**GENOA CHARTER TOWNSHIP  
PLANNING COMMISSION  
PUBLIC HEARING  
JULY 14, 2014  
6:30 P.M.  
AGENDA**

<b>Attention:</b>	Mike Archinal, AICP Township Manager
<b>Subject:</b>	Buffalo Wild Wings Addition – Site Plan Review #2
<b>Location:</b>	900 Latson Road – west side of Latson Road, north of Grand River Avenue
<b>Zoning:</b>	MU-PUD Mixed Use Planned Unit Development District (with underlying zoning of GCD General Commercial District)

**Re: Buffalo Wild Wings Building Expansion  
Site Plan Review #2**

RE: Buffalo Wild Wings  
900 S. Latson  
Site Plan Review of Addition

SHEET #  
**A.201**

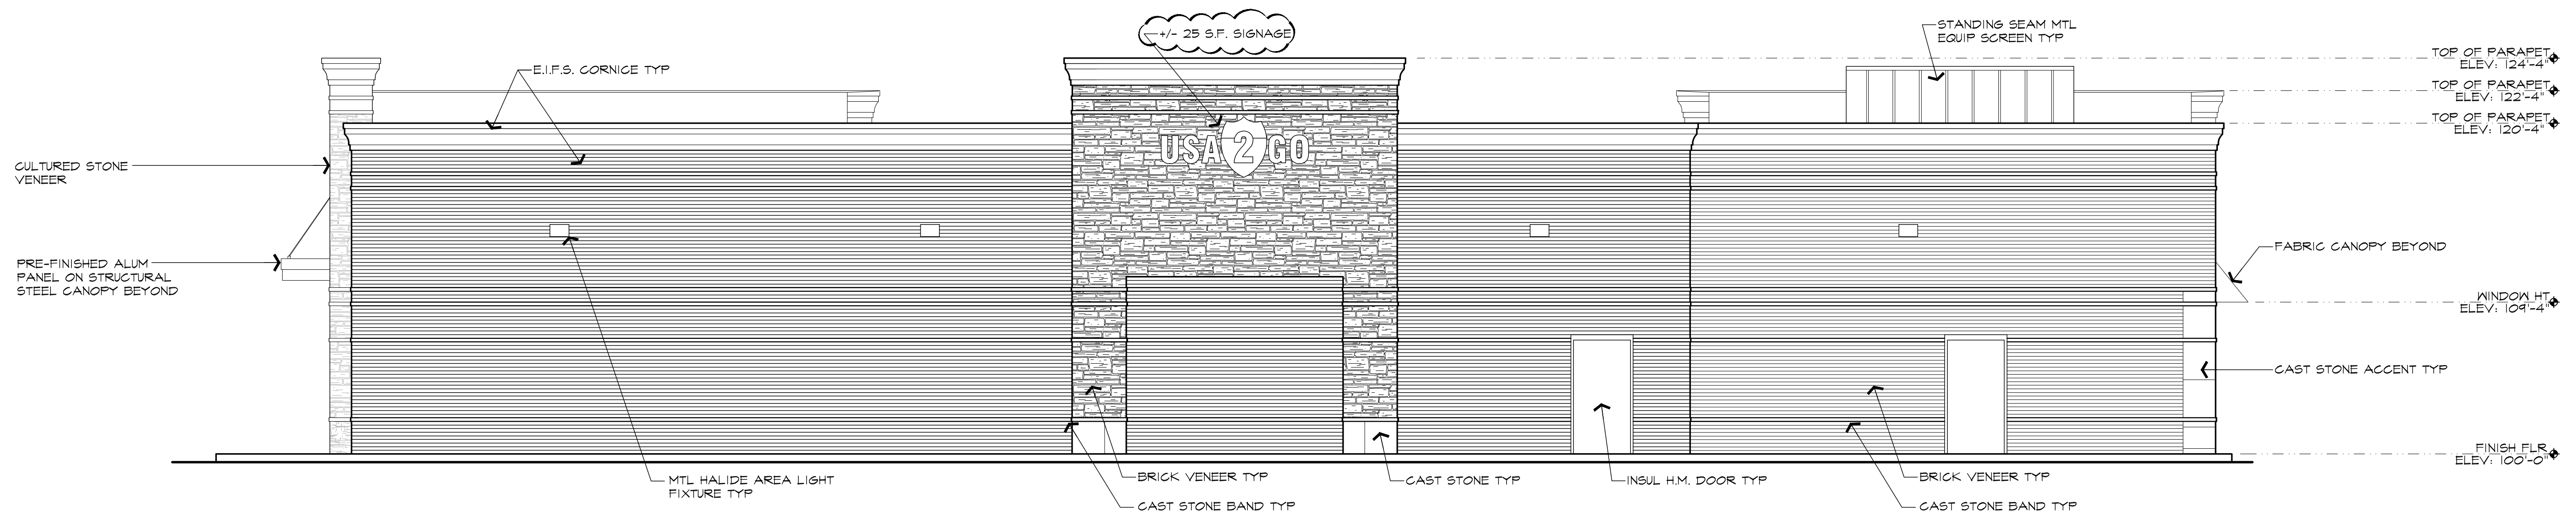
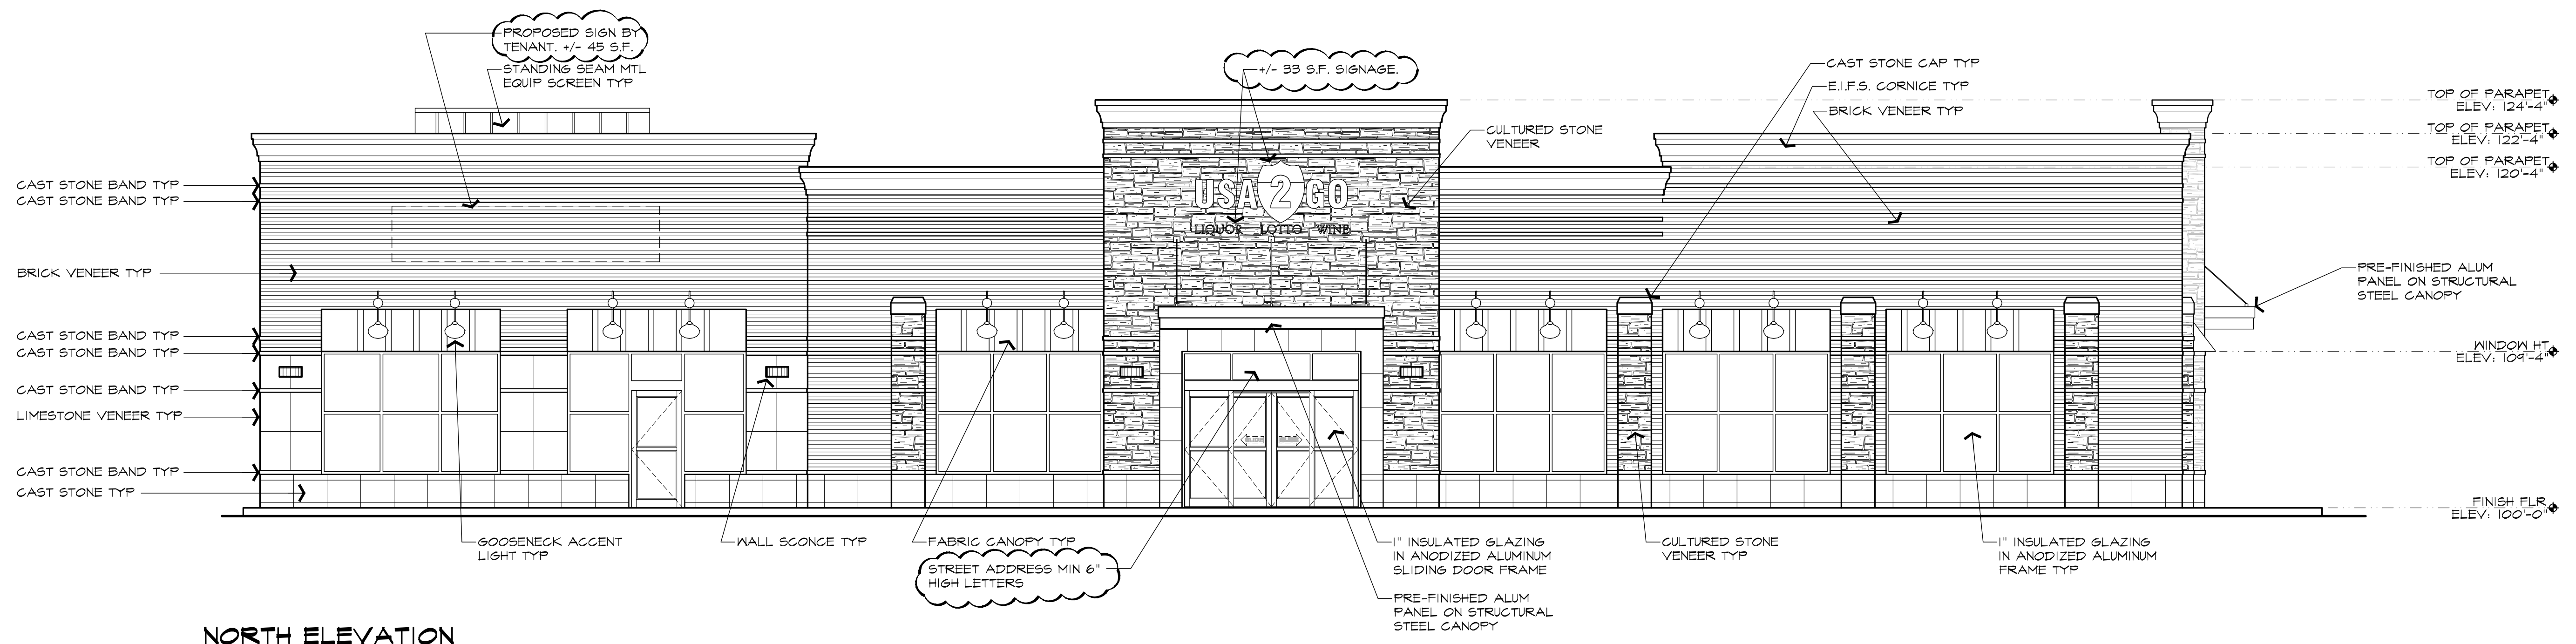
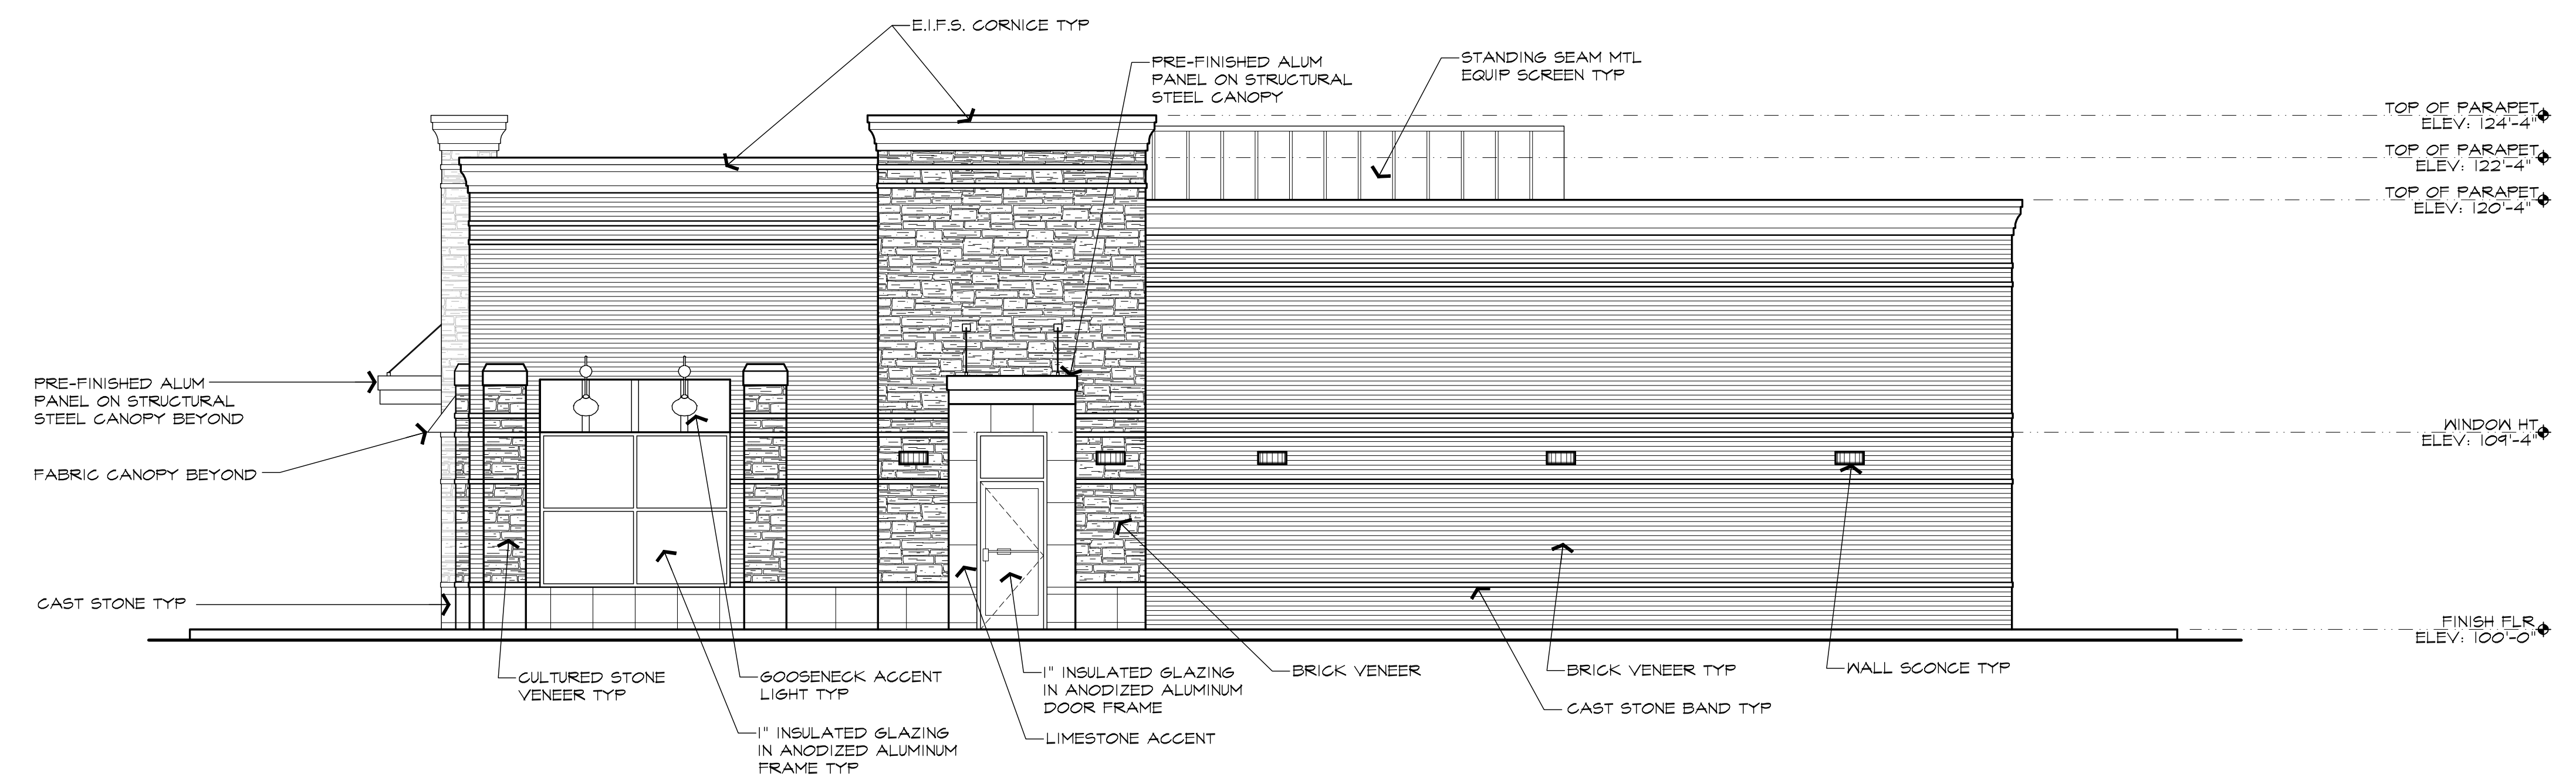
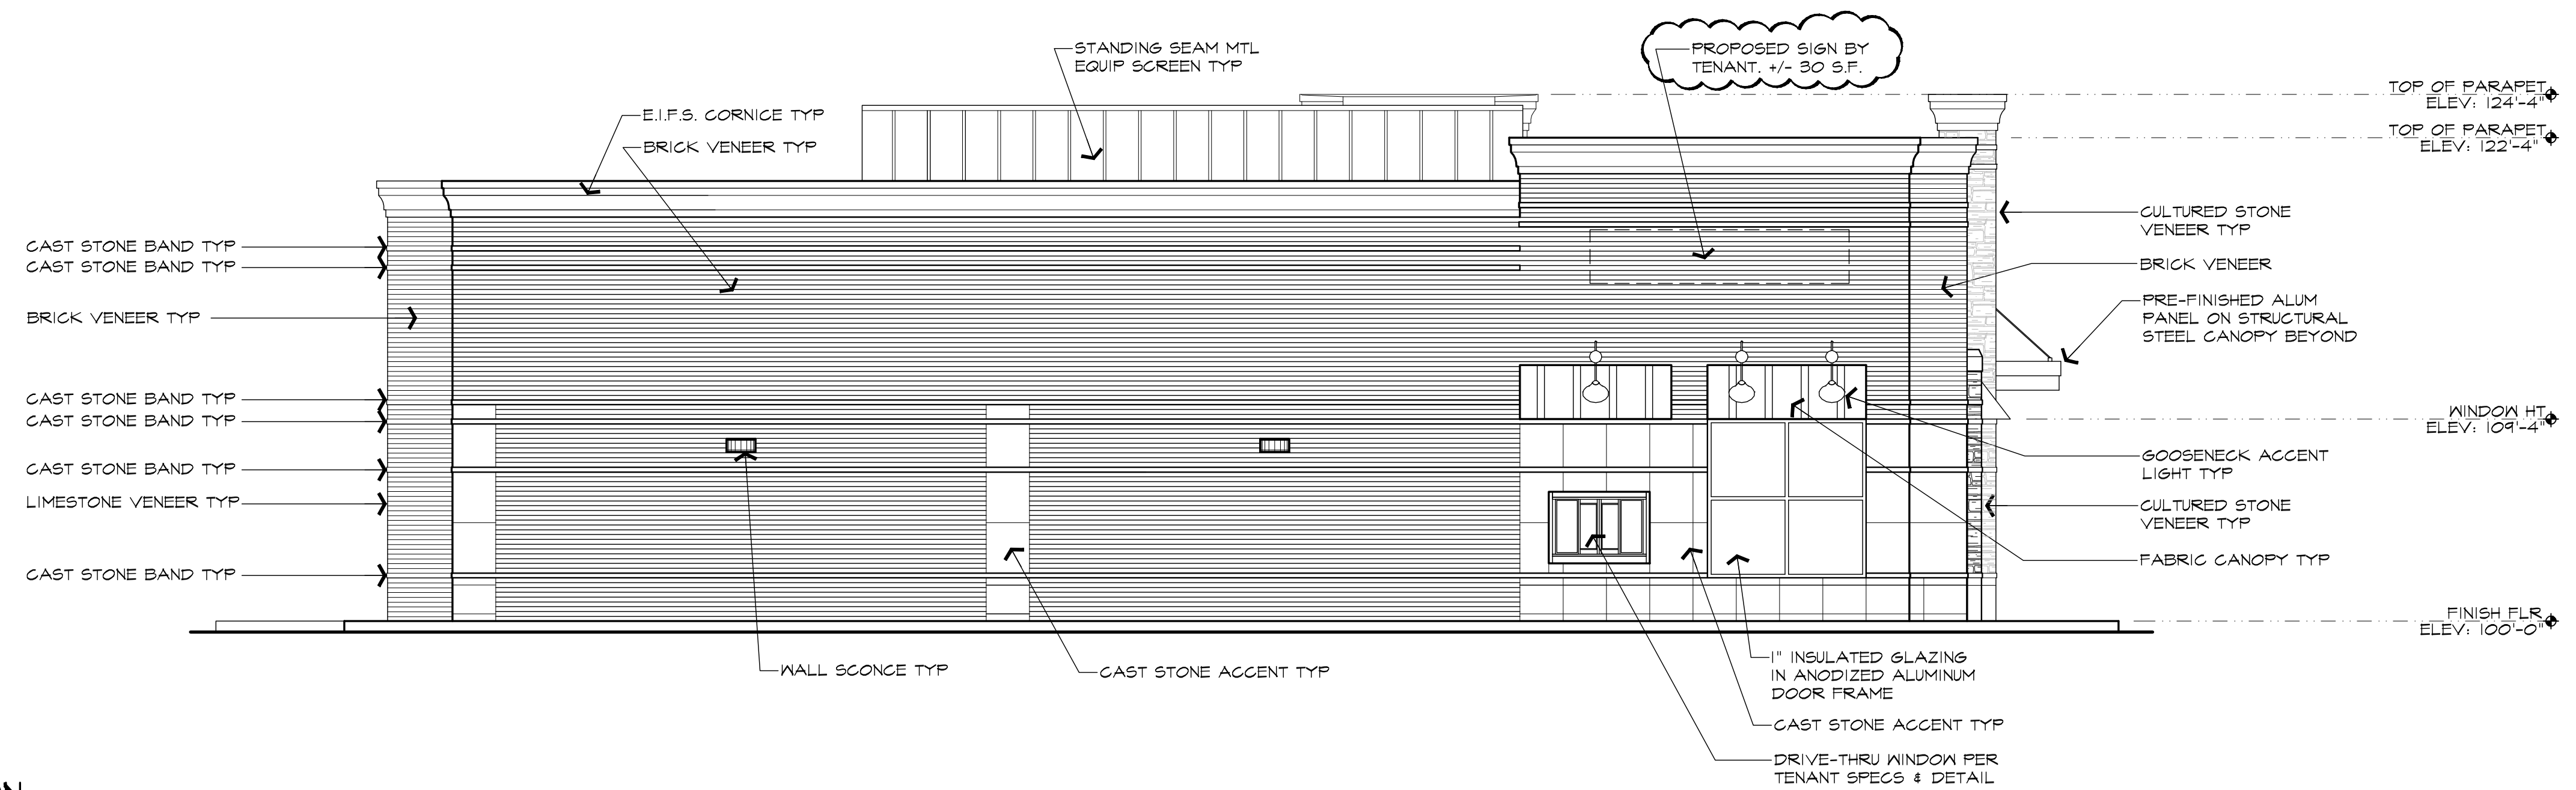
**IFC 105.4.2**
3. The building shall include the building address on the building. The address shall be a **minimum of 6"** high letters of contrasting colors and be clearly visible from the street. ***(The location and size shall be verified prior to installation. Sheet A.201 now indicates where the address will be located.)***

14005 **LS-1**

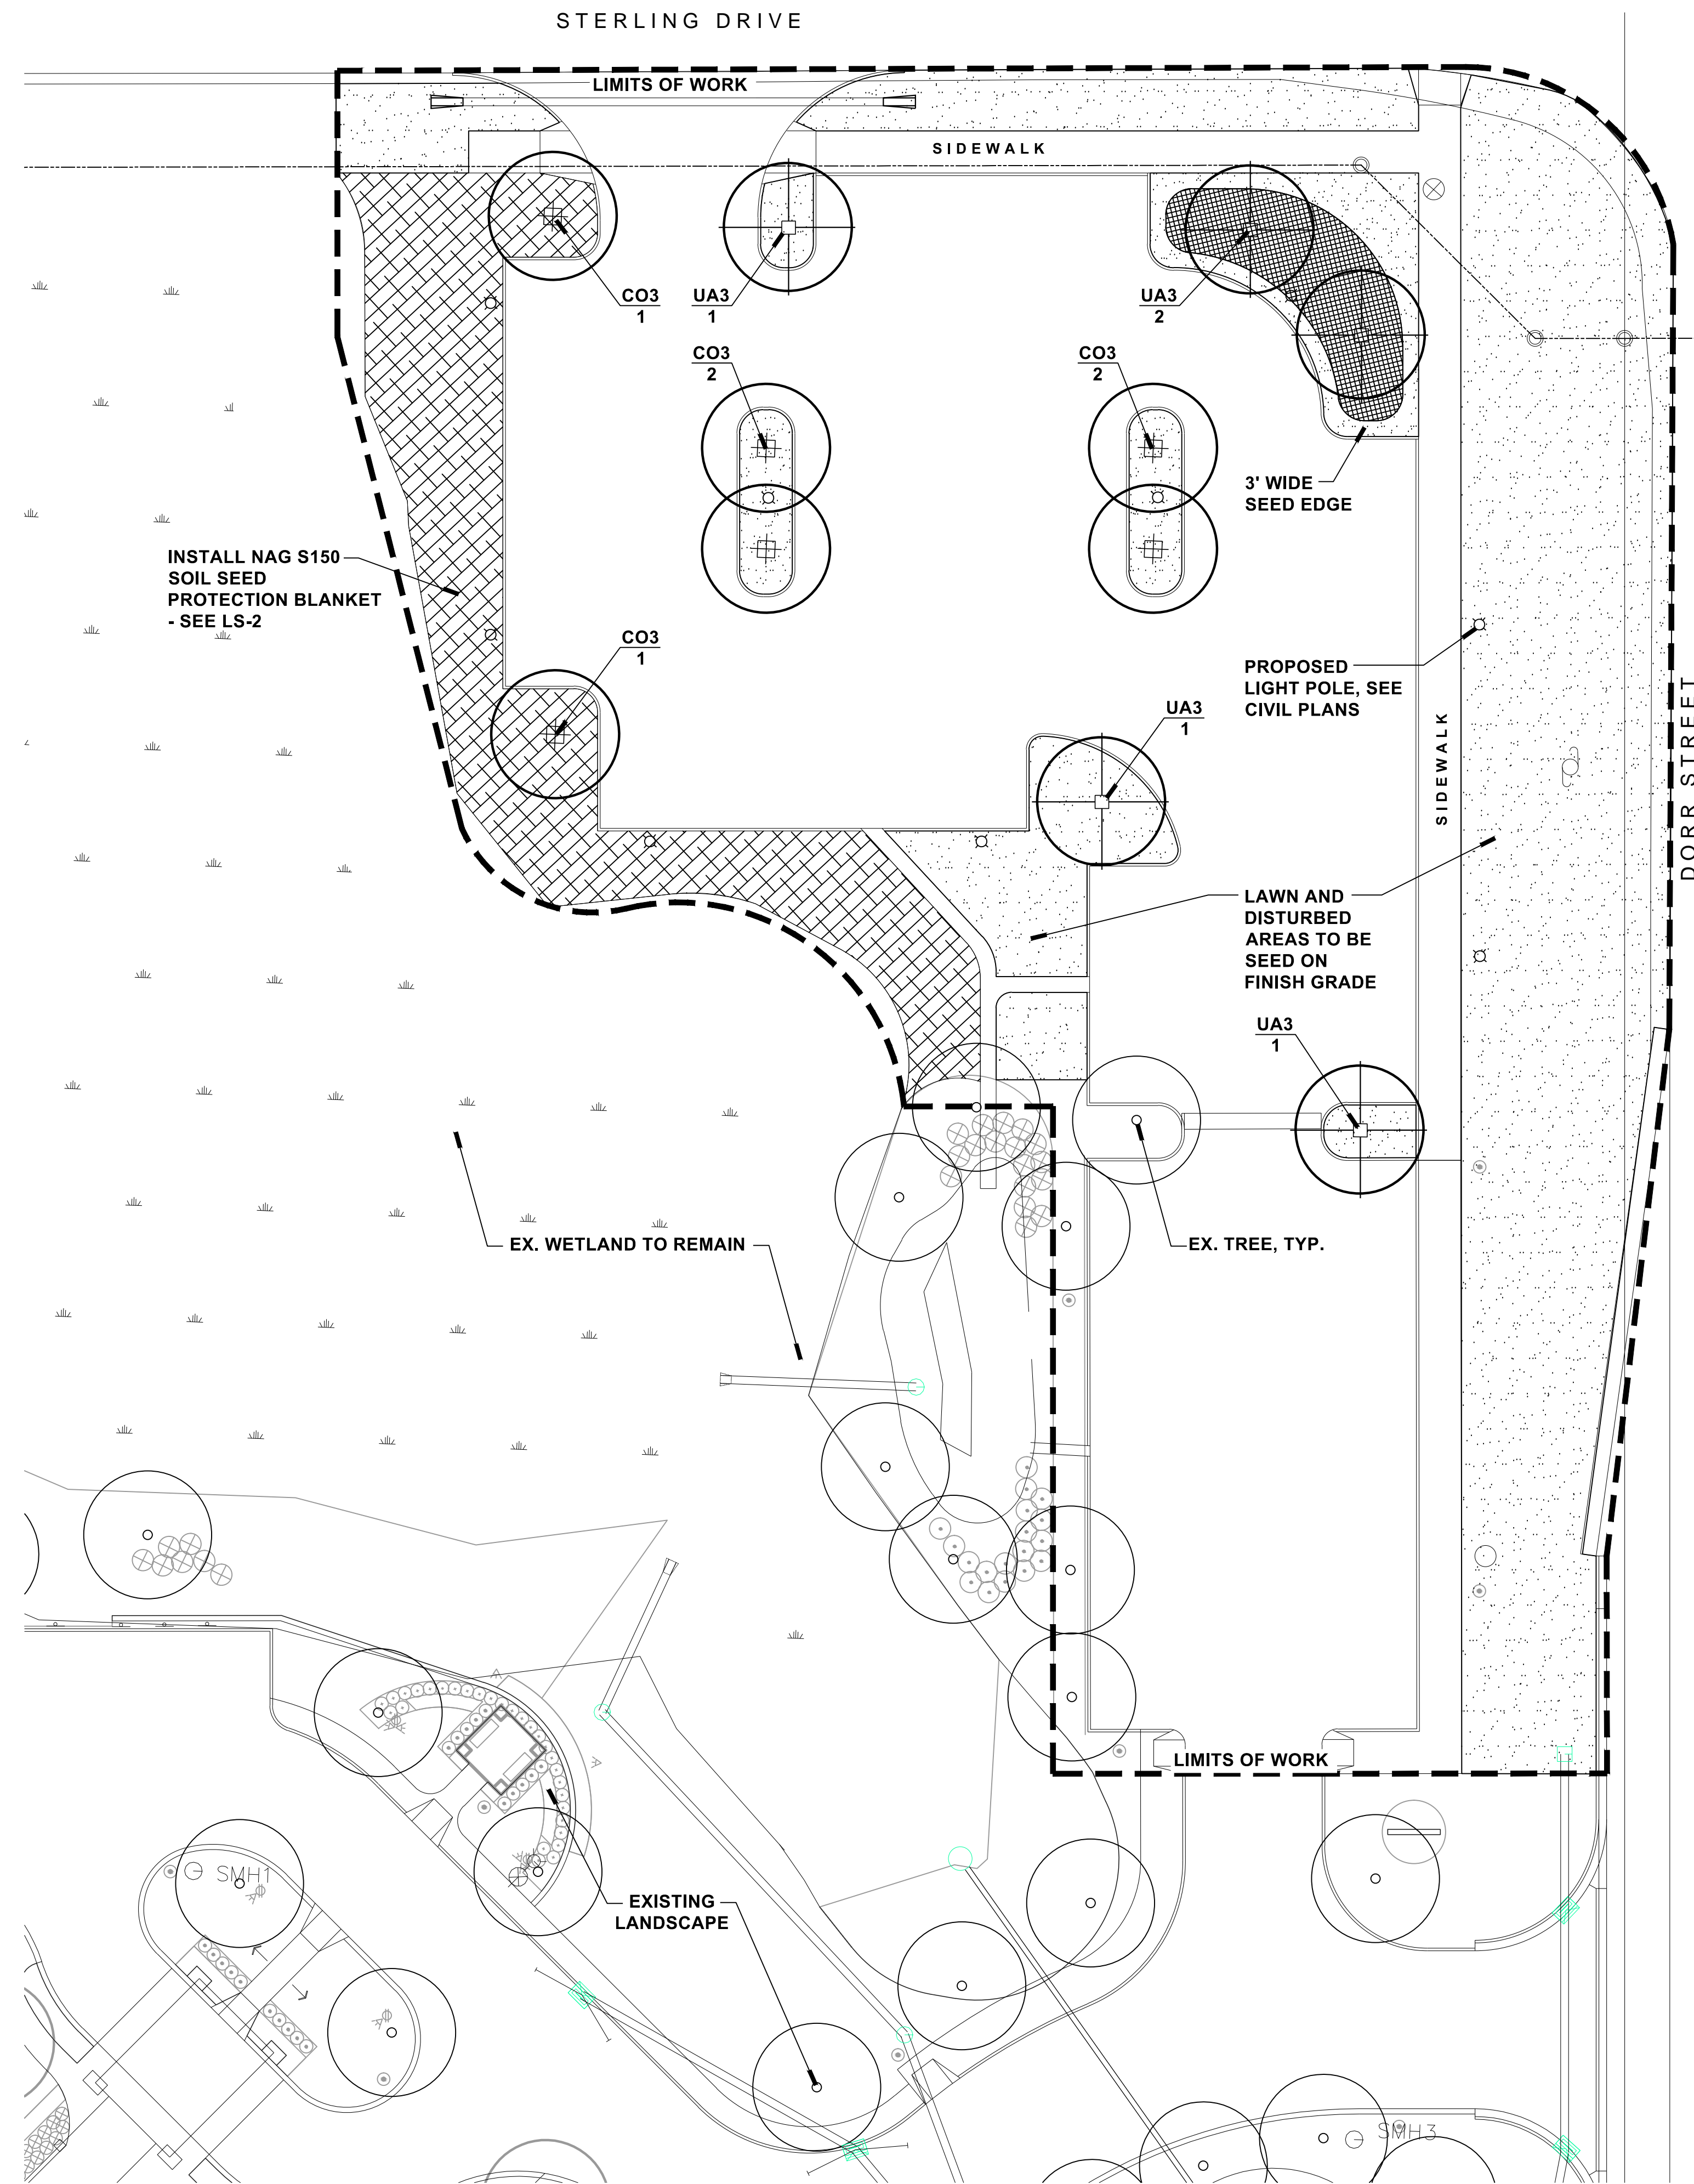
7. **Landscaping.** The site plan identifies landscape islands within the expanded parking lot that meet the required width of 10’. Parking spaces are not drawn on sheet LS-1, but it appears that the islands are the same length as the parking spaces. Section 12.02.04 (g) requires that the length be 2’ shorter than adjacent spaces to improve maneuvering.
